STAFF RECOMMENDATION
120-122 Third Avenue South
September 21, 2016

Application: Alterations
District: Broadway Historic Preservation Zoning Overlay
Council District: 19
Map and Parcel Number: 09306405500
Applicant: Sandi Borchetta
Project Lead: Paul Hoffman, paul.hoffman@nashville.gov

<p>Description of Project: The applicant requests approval of changes that were made without review and approval of the Metro Historic Zoning Commission (MHZC). The applicant repainted, removed parapet tiles and a chimney, installed signage and replaced storefront windows.</p> <p>Recommendation Summary: Staff recommends approval of this application with the conditions:</p> <ol style="list-style-type: none">1. Paint is removed using a technique approved by Staff or the building is repainted a brick color approximating the original color of the brick, or white, final color to be approved by Staff;2. The parapet tiles are replaced;3. The metal sidelights in the south entryway are replaced with clear glass sidelights;4. Unpermitted signage is removed; and,5. All violations are corrected with 60 days of the date of the hearing. <p>With these conditions, Staff finds that the changes to the building will m

Figure 5. Historic images of the building. The photo on the left is undated. The photo on the right is dated 1992.

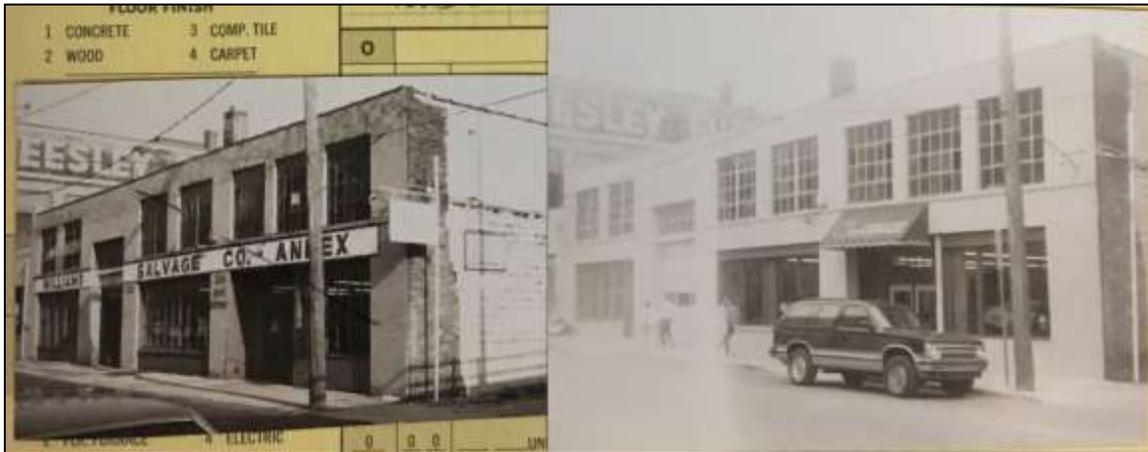
Display Windows: In the middle section of the building, a non-historic bay of four windows was replaced with four replacement anodized aluminum windows. Staff finds the windows to be appropriate for several reasons. Metal windows were likely original to this building, the building may not have had a more traditional storefront like those seen on Broadway, the new design is simple and doesn't seek to replicate a historic design that may never have existed, and the windows were selected to match those on the other side of the entryway. The project meets section II.C for display windows.
